*The Reno Creek ISR Project
Campbell County, Wyoming*

**Revised RAI Response Package:
Technical Report**

December 2014

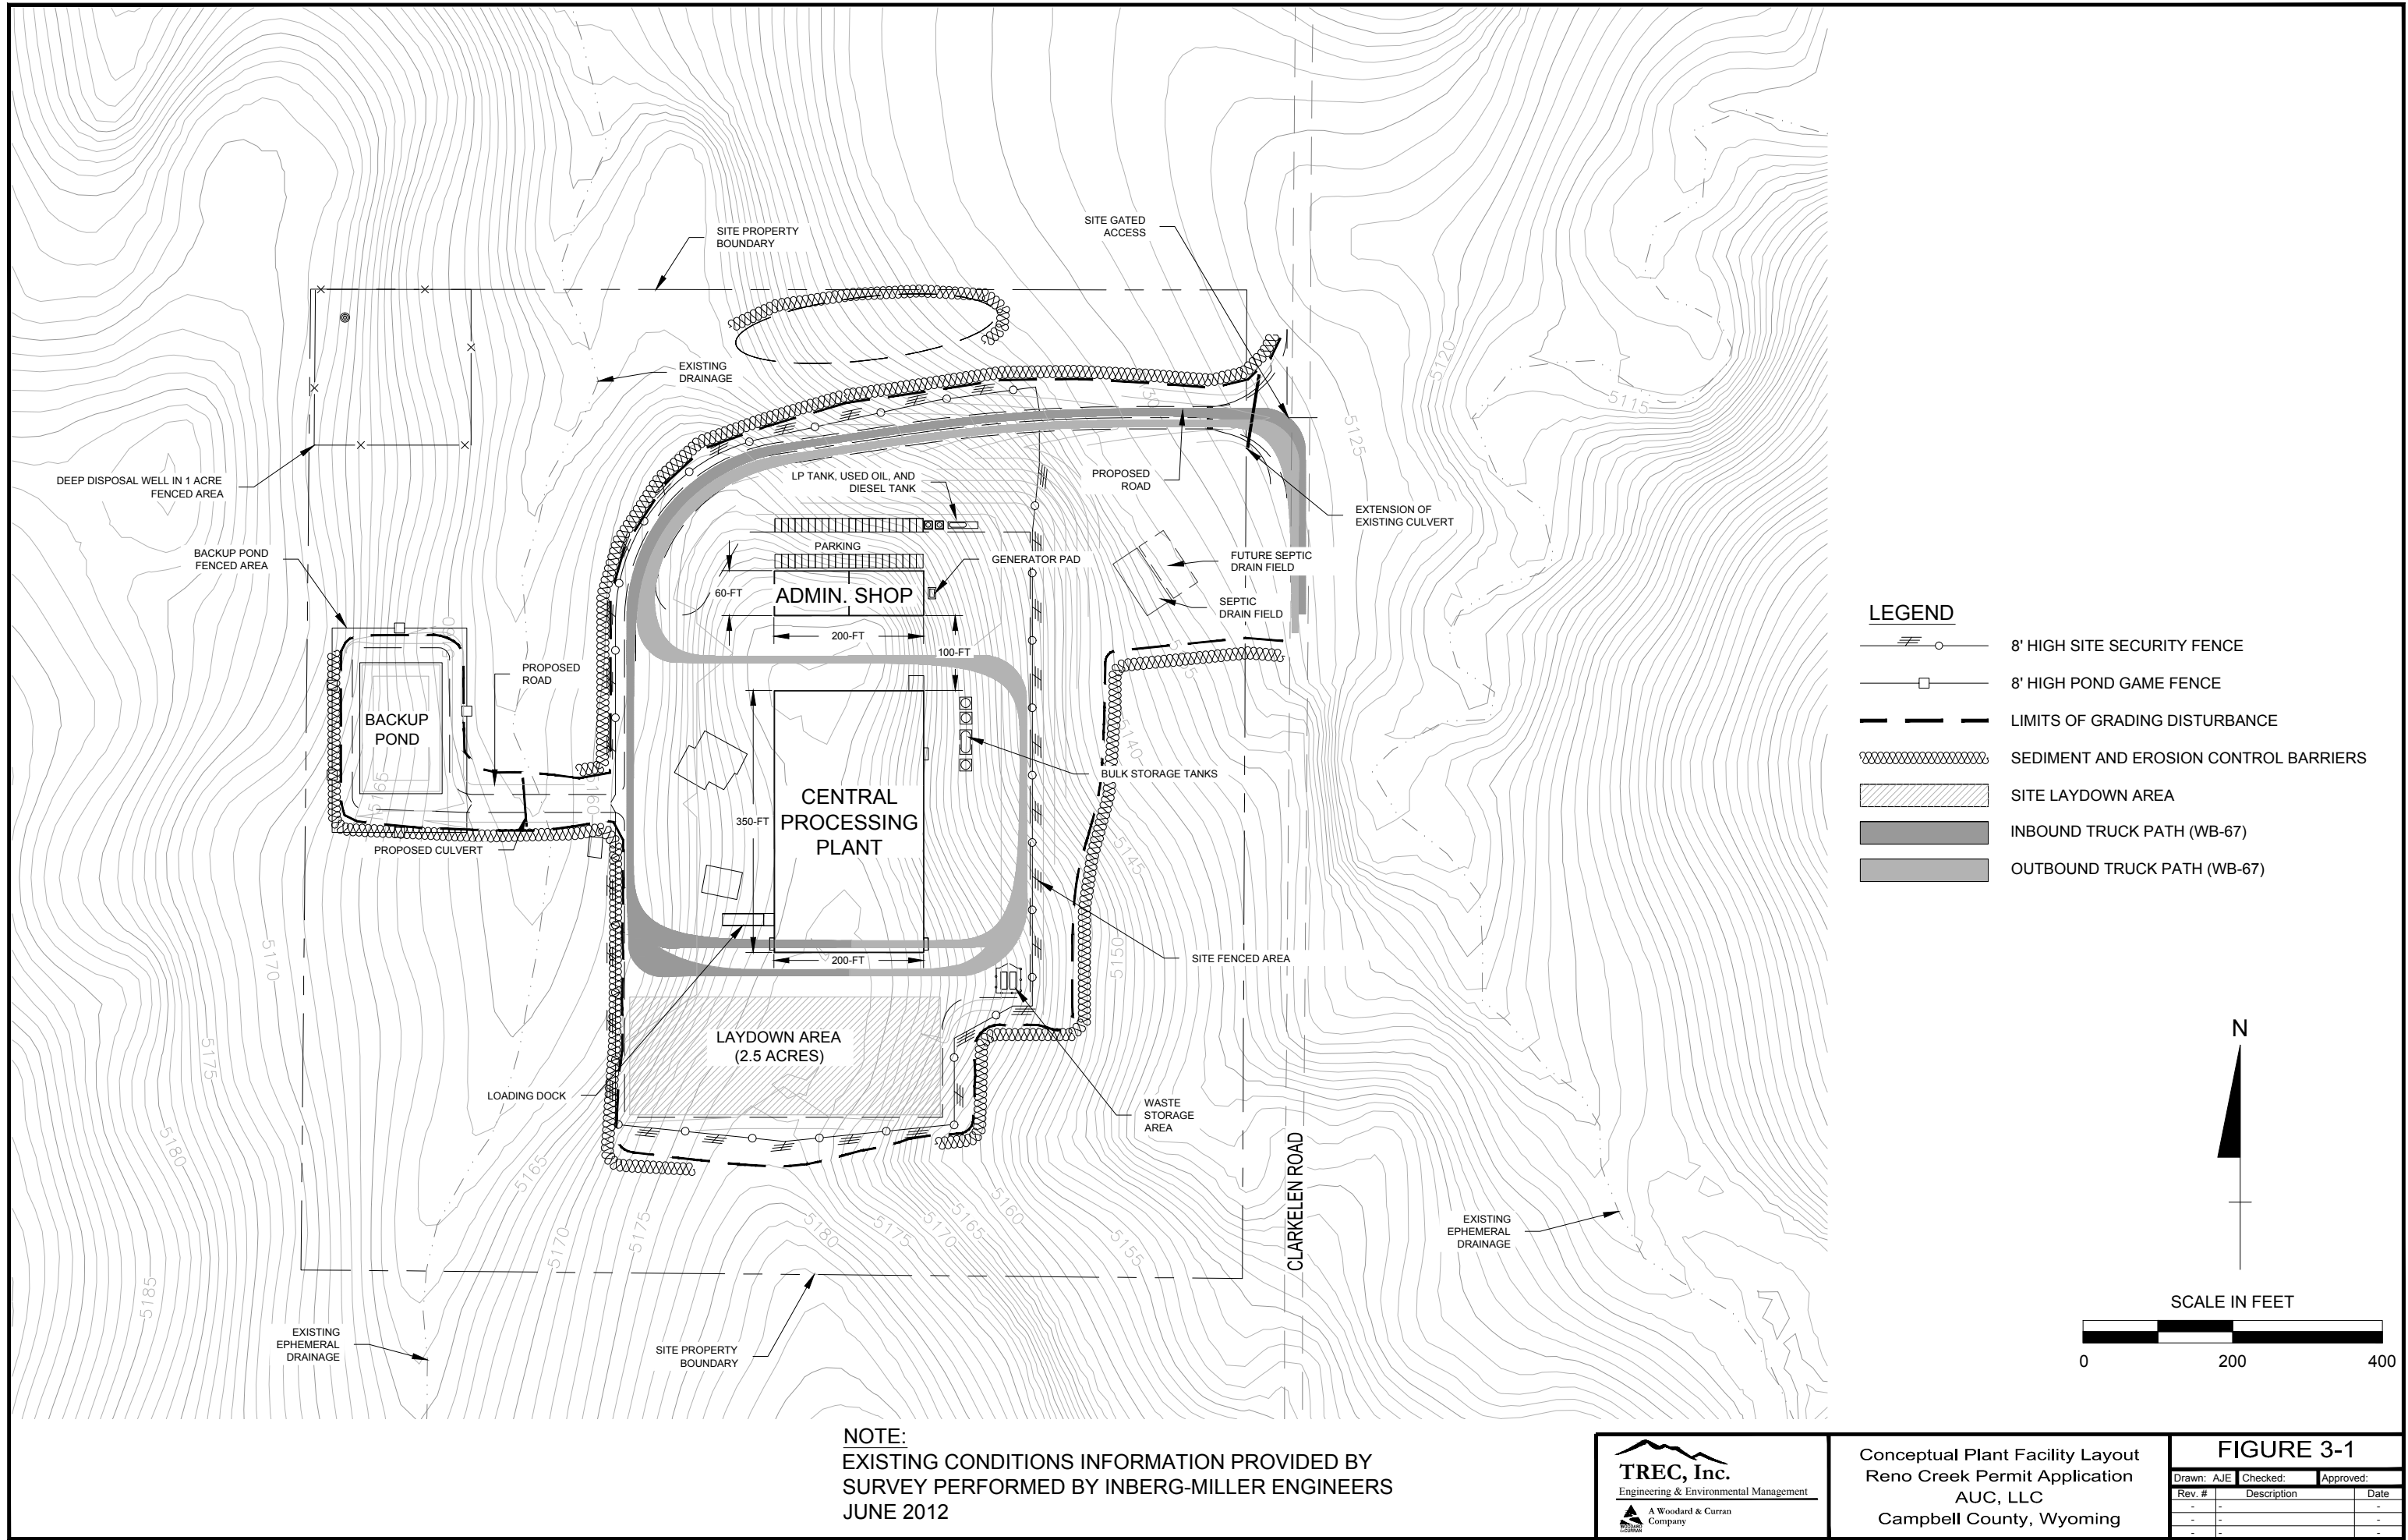
In TR Section 3.0, Figure 3-1 depicts a conceptual facility layout for the central processing plant and backup pond. The applicant supplemented the information with preliminary construction drawings submitted in the supplement data (ML13213A064).

Please revise the TR to incorporate the proposed changes in the supplemental data submittal.

AUC has updated TR Figure 3-1 with the revised site plan provided in the supplemental data package.

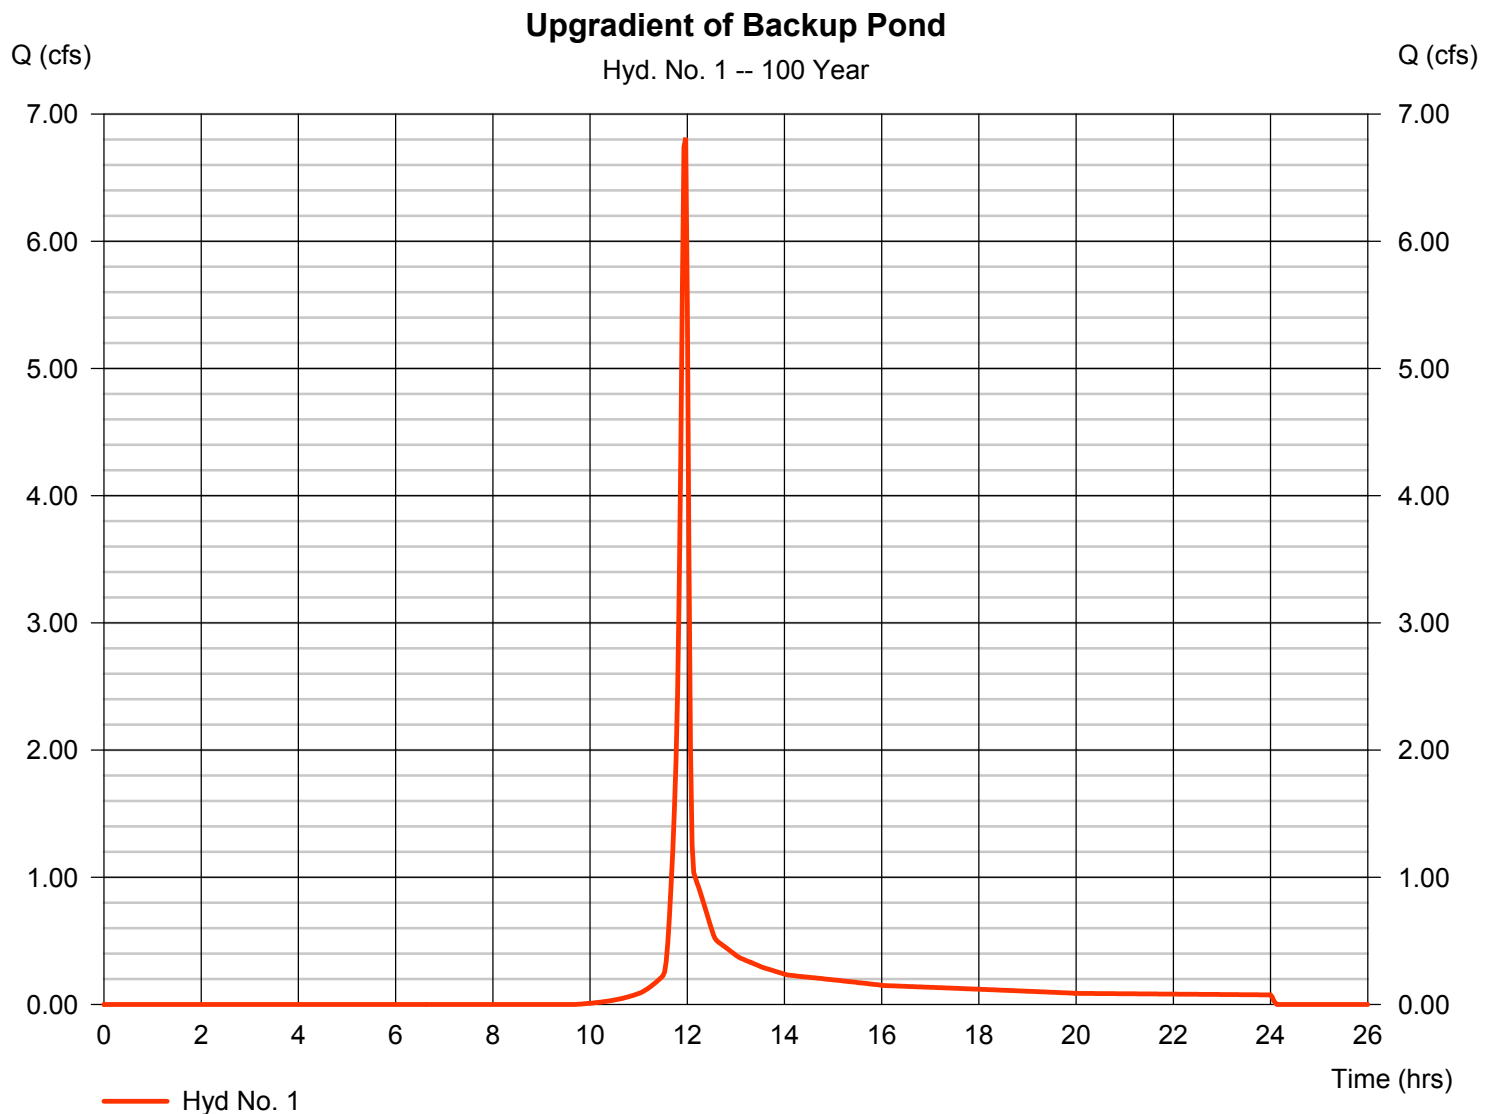
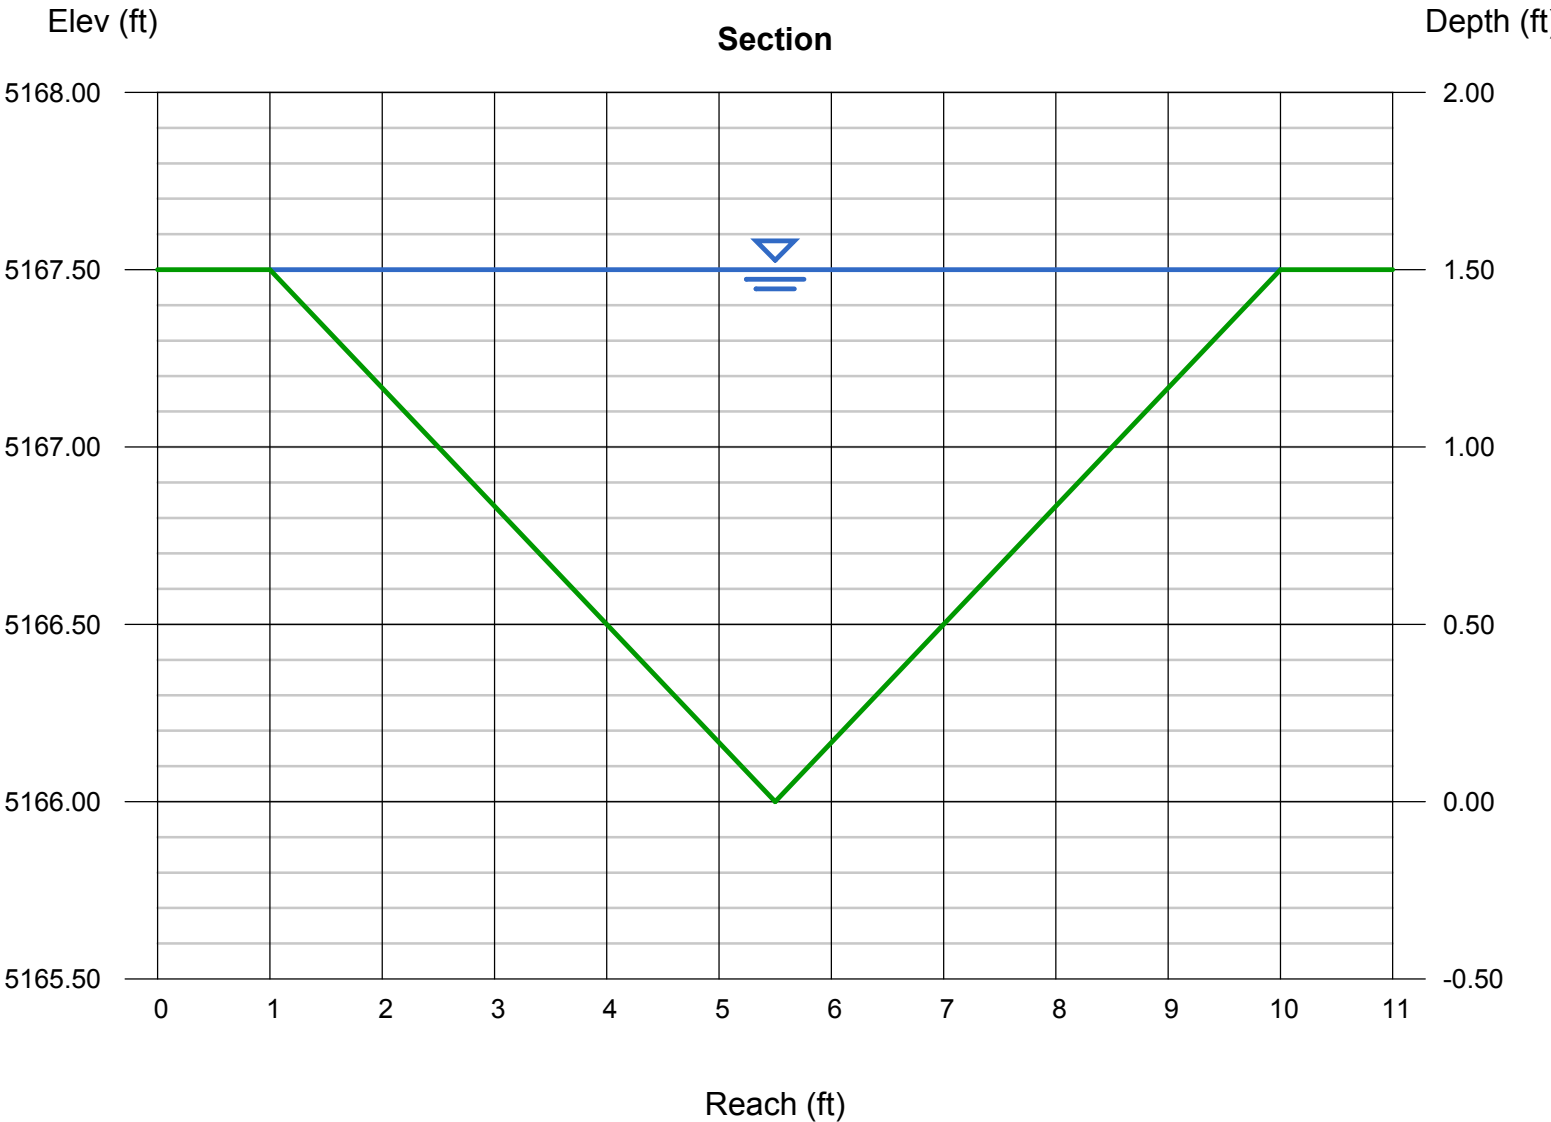
In the Supplemental data (ML13219A203) on Sheet CD-9.2 “DRAINAGE DETAILS”, the details indicate a 1.5-foot minimum depth to the “west interceptor ditch” surrounding the backup pond. On Sheet C-9.3 “STORM DRAINAGE: WEST INTERCEPTOR DITCH” in the supplemental information, the maximum elevation of the base on the drainage ditch is reported at 5166.841 (no units).

Hydraulic calculations use the Manning's equation. A manning's n value of 0.1 is assumed based on the diversion ditch consisting of good stand of grass six to twelve inches in length (Table 3.4, McCuen). The diversion channel cross-section consists of a v-ditch with 3H:1V side slopes and a minimum depth of 1.5 feet. A minimum slope of 1.2% is assumed based on the longitudinal profile presented on Sheet Civil Site Construction Drawings C-9.3 (i.e. location of channel cross-section with lowest capacity).

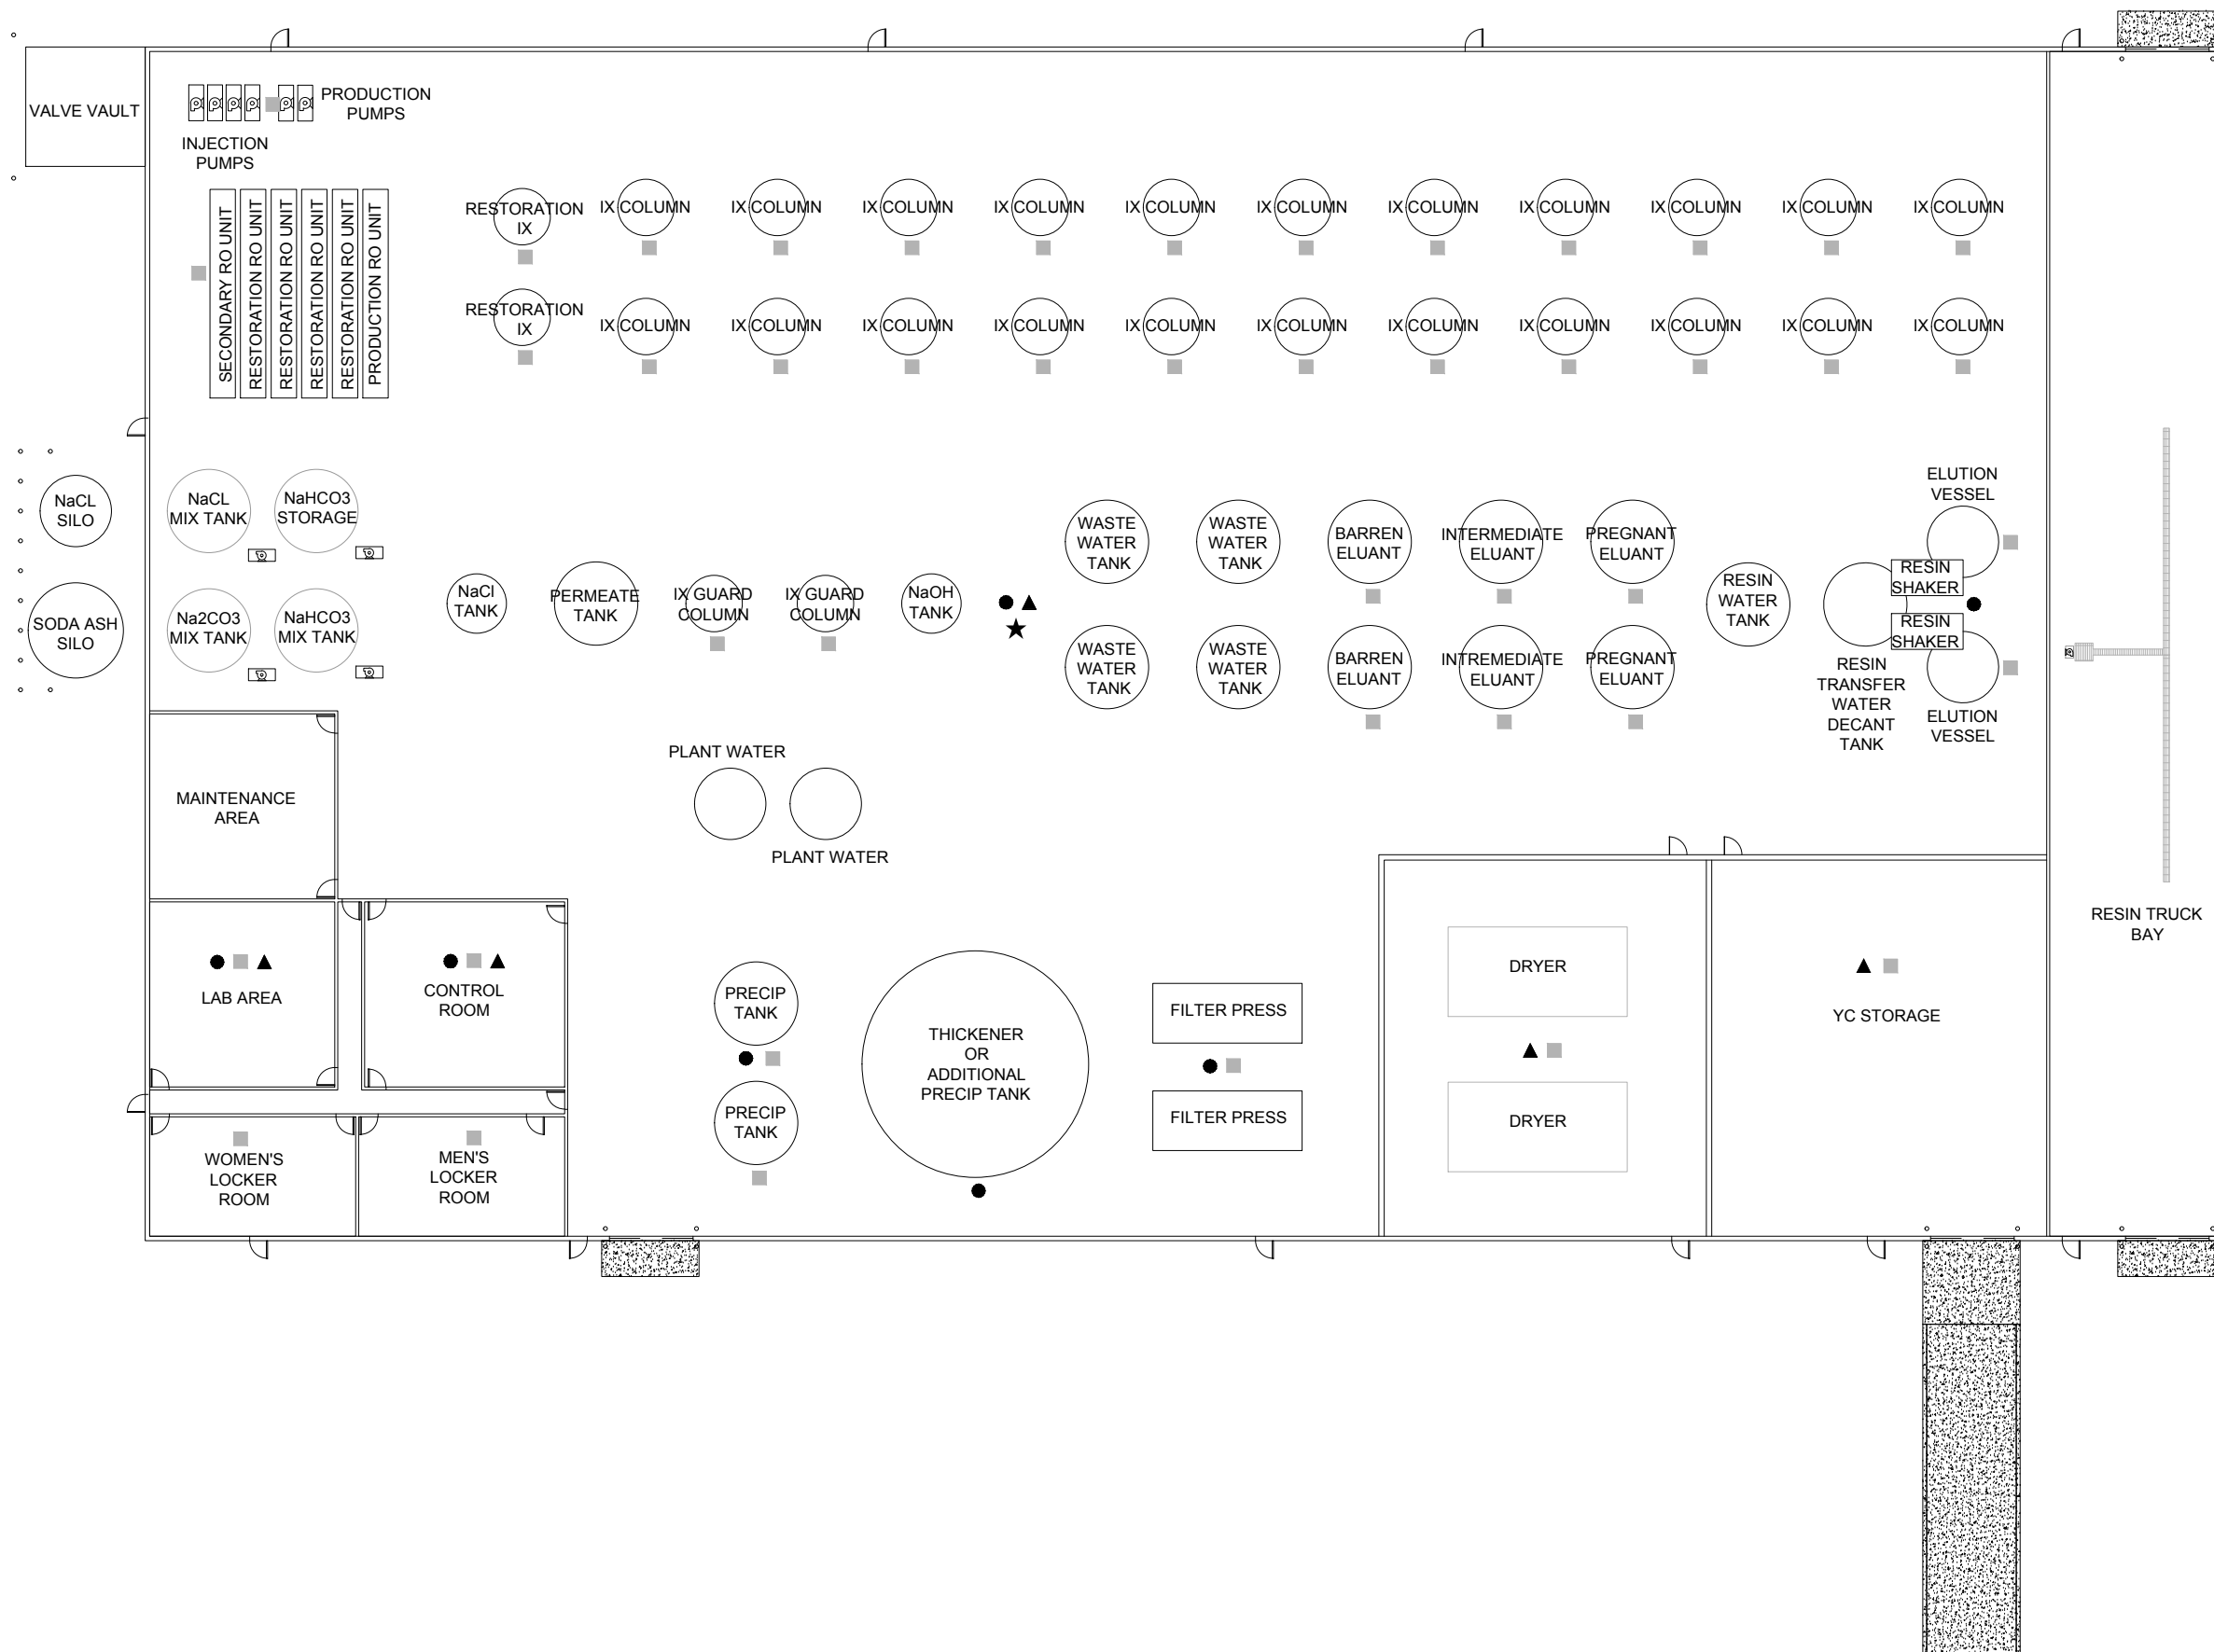
Provide a technical basis for not establishing general area surveys in the drying and packaging area or include in the application a commitment that general area surveys in the yellowcake drying and packaging area will be conducted. If such surveys will be conducted, then reflect the locations of such surveys in Figure 5-23.

AUC has revised Section 5.7.2 to include the yellowcake drying and packaging area as shown below. Also, due to the new figure (Fig. 5-2) developed as a result of RAI-44, the figure referenced in this response (RAI-45) has been re-numbered within the application to Figure 5-3 and depicts the location for the applicable surveys.
